COMMITTEE REPORT

ITEM NO. 11

App No.: 172118/FUL

Address: 40 Silver Street

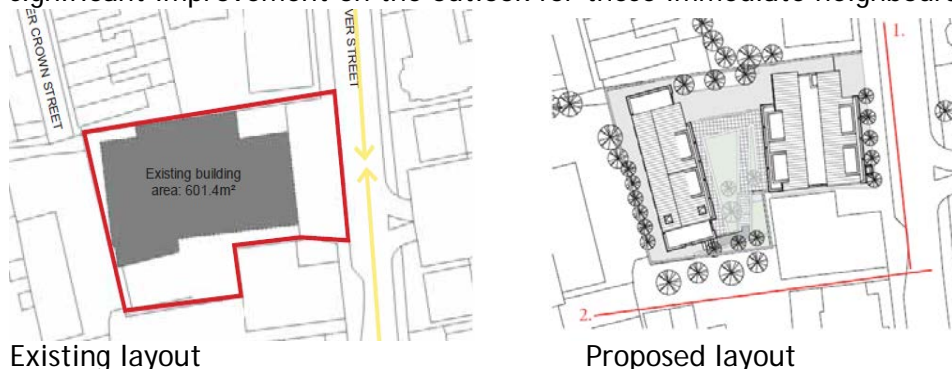
- 6.16 It is also the intention of emerging local plan policy H12 to control where student housing will be provided in the future to prevent the over-concentration of student accommodation which needs to be balanced against other types of housing. It was found to be inappropriate to apply this policy against the issue of the principle of the proposed development as the applicant is not currently required to demonstrate the need for it. However, the background to the policy refers to the need to retain sites for general housing too. The supporting text explains "*Whilst it is likely that purpose built student housing can free up some existing homes to meet more general needs, there are many sites where development for students prevents a potential housing site being used to help to meet the more*

pressing needs for general housing, including affordable housing. Development for students should therefore be limited to established student locations, unless a specific need for a development in a certain location can be clearly demonstrated”.

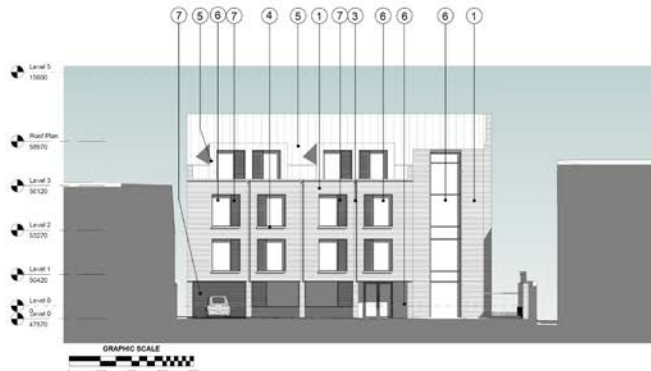
- 6.20 However, due to the proposed height and mass of the new buildings, more residents living nearby would find their outlook and amenities harmed through either loss of light, over bearing development and loss of privacy. This would particularly apply to residents living to the north of the site in Upper Crown Street and Platinum House and residents that might be introduced if 62-68 Silver Street were to change to residential use. Rimaud House, to the west, is a part three, part two storey building set on higher ground than the application site so that relationship is of less cause for concern.

1 Elevation 1 - Silver Street
1: 100

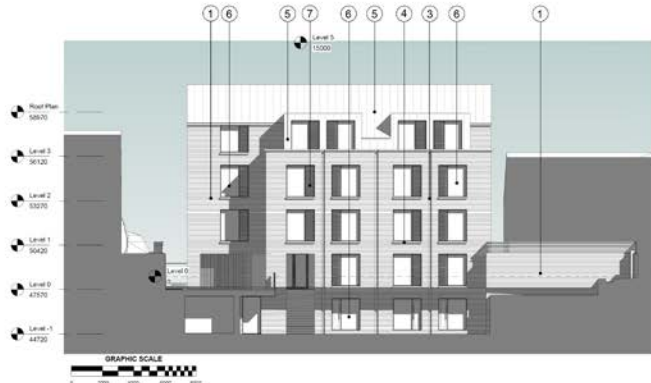
- 6.9 The existing commercial building on the site is approximately 2 domestic storeys in height and when viewed in the context of the surrounding taller buildings is incongruous in the streetscene. The extant planning permission granted for application 150885/FUL for residential development proposed an acceptable building 3.5 storeys in height. By contrast, the proposal at 4 storeys (plus roof) would be significantly higher than the buildings on either side as can be seen from the Silver Street elevation below.

- 6.14 In conclusion it is considered that the height and depth of Block A would be excessive and the bulky design would be exaggerated further by the repetition of large rectangular openings and the use of dormers that give a top heavy appearance. Block B benefits from being less high and deep but the design still gives an appearance of bulk which would appear incongruous in the cramped courtyard setting. Due to their proximity the two blocks with the link building would read as one block from many aspects so it is considered that the proposal would be an overdevelopment of the site. The proposed development would fail to secure the high quality design required by Policy CS7, with consequent harm to the character and appearance of the area.

2 Elevation 2 - Block A Courtyard
1: 100

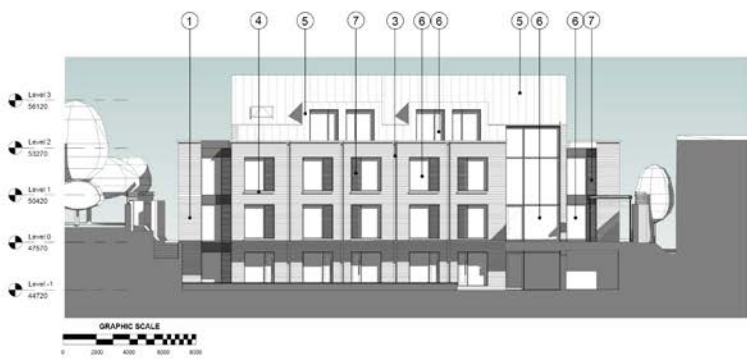
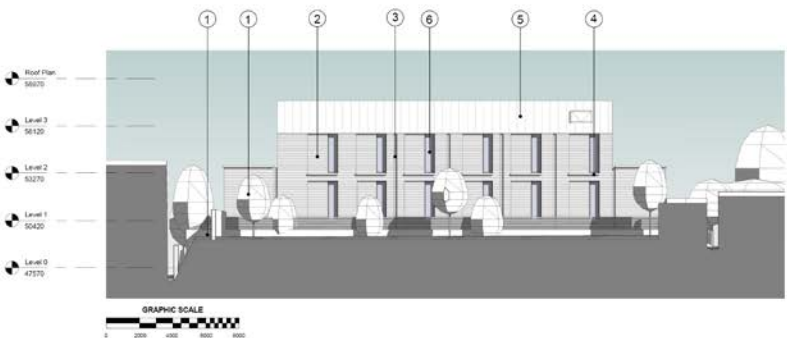
6.13 The central courtyard is shown to be pleasantly laid out but at 170 Square metres would be inadequately sized to cater for the proposed 62 students. Also, the short distance between the two blocks would make this space feel

very over looked and dominated by the mass of the buildings. Block A's elevation would be about 14 metres high on the east side and Block B's elevation would be 11 metres high on the west side. The illustrations shown below suggest how this may appear:
